025-18-CA

709 HINDSDALE STREET

## APPLICATION FOR A CERTIFICATE OF APPROPRIATENESS – STAFF REPORT

Nature of Project: Remove historic window; install salvaged historic window

PHOTO #1

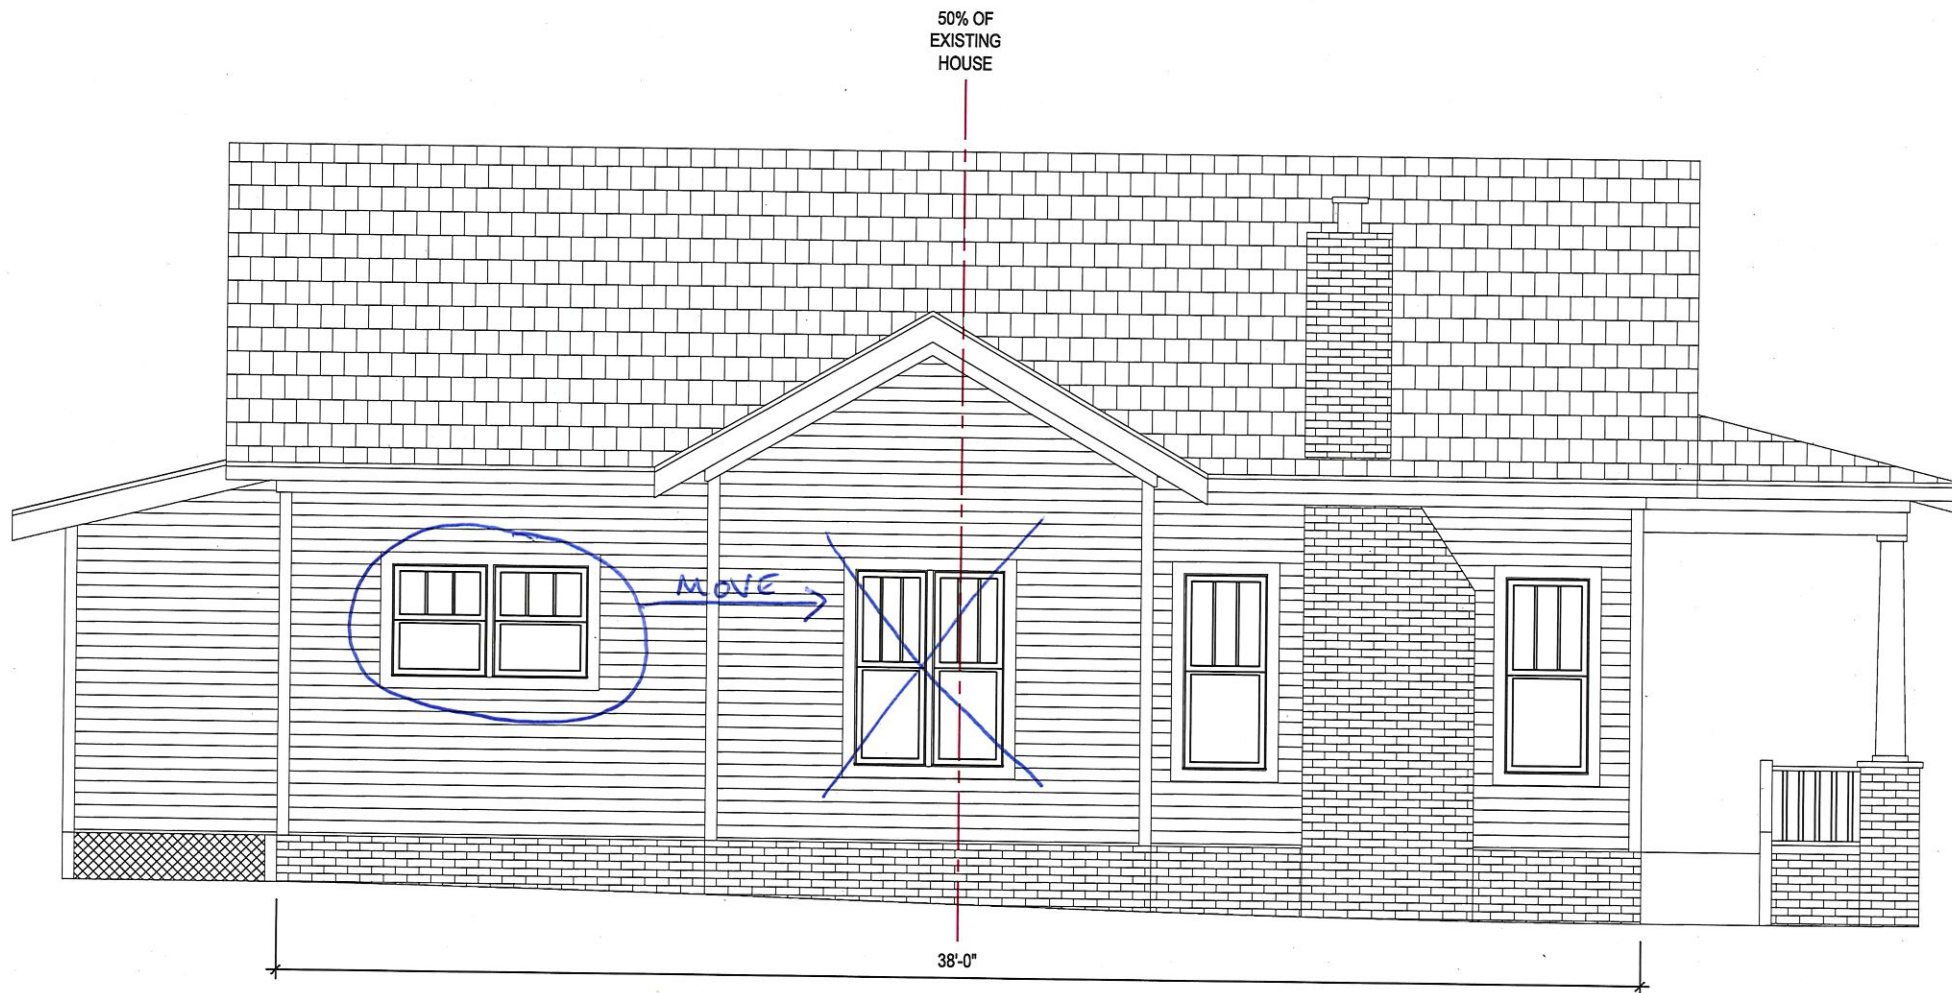
- 3\* The applicants propose removing one of a pair of 3-over-1 windows centered on the gable-end bump-out on the east side (left) of the house. The window is the same height as two windows that flank the fireplace towards the front of the house, but are narrower.

- 4\* The applicants propose replacing the existing window with one of a pair of 3-over-1 windows of different dimensions that will be removed from elsewhere on the house. The "replacement" window appears to be nearly square and is much wider in proportion than the existing window.

Staff suggests denial of the application.
